White Flint Sector Plan

worksession #5 march 30, 2009

GARRETT PARK ESTATES - WHITE FLINT PARK CITIZENS' ASSOCIATION

**Presentation to the Montgomery County Planning Board
March 30, 2009**

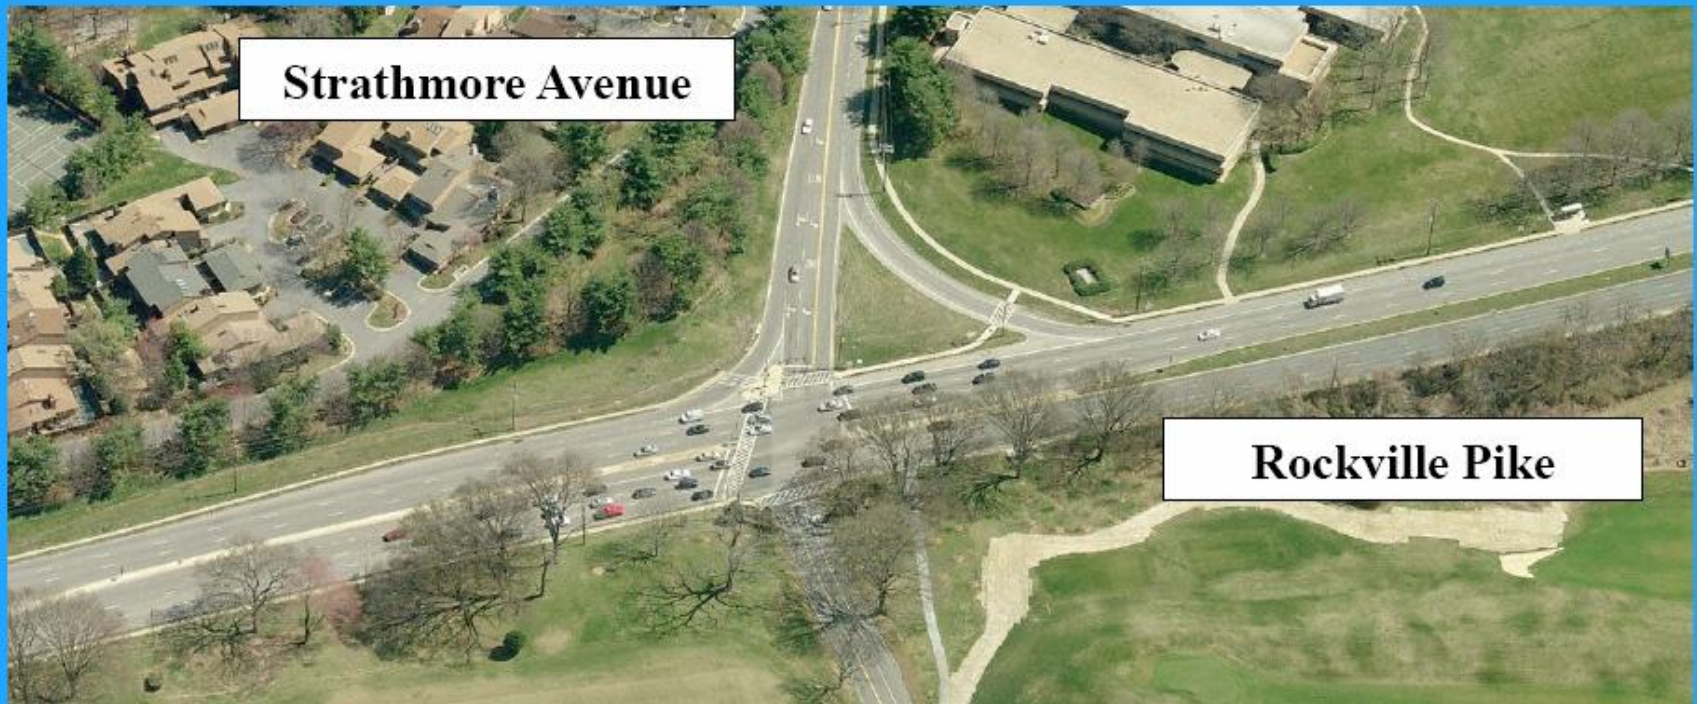
- Transportation Analysis - Strathmore Ave. and Rockville Pike
 - “At ...Strathmore Avenue (MD 547) the peak hour forecast CLV is **1852...**”

“These forecasts are higher than the current CLV congestion standard....They are typical, however of CLV forecasts for intersections on heavily traveled arterial routes in Sector Plans where smart growth development is being encouraged by County Policy, including the **Silver Spring CBD** Sector Plan in 2000, the **Bethesda CBD** Sector Plan staging analysis in 2004...”

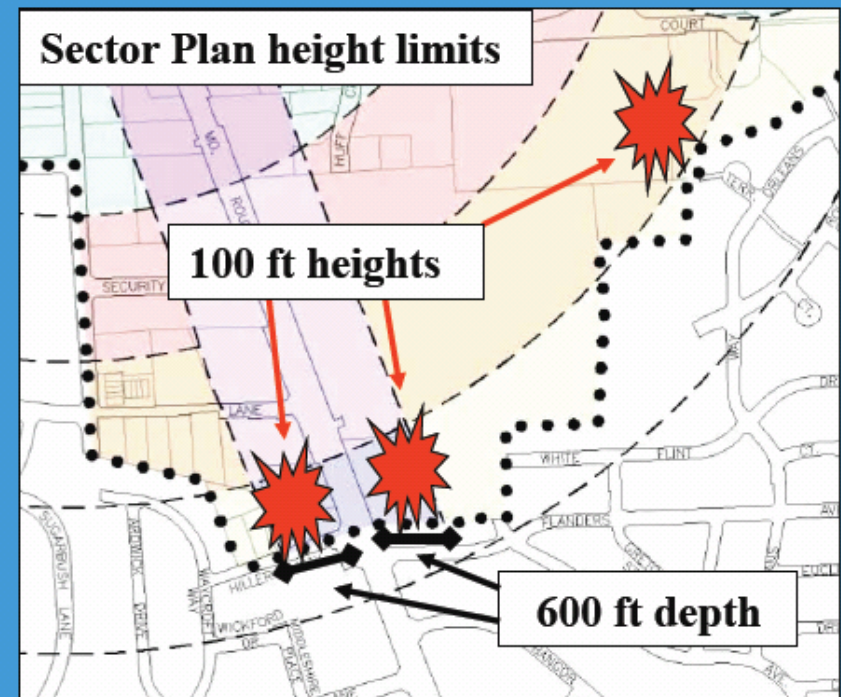
- Compatible building heights
 - Object to allowing 100 ft buildings adjacent to communities on both sides of Pike
 - Object to envelope extending 600 feet in from Pike
 - Existing medical bldg 75 ft high, extends ~67 ft deep
 - 36 ft – 50 ft maximum height at border
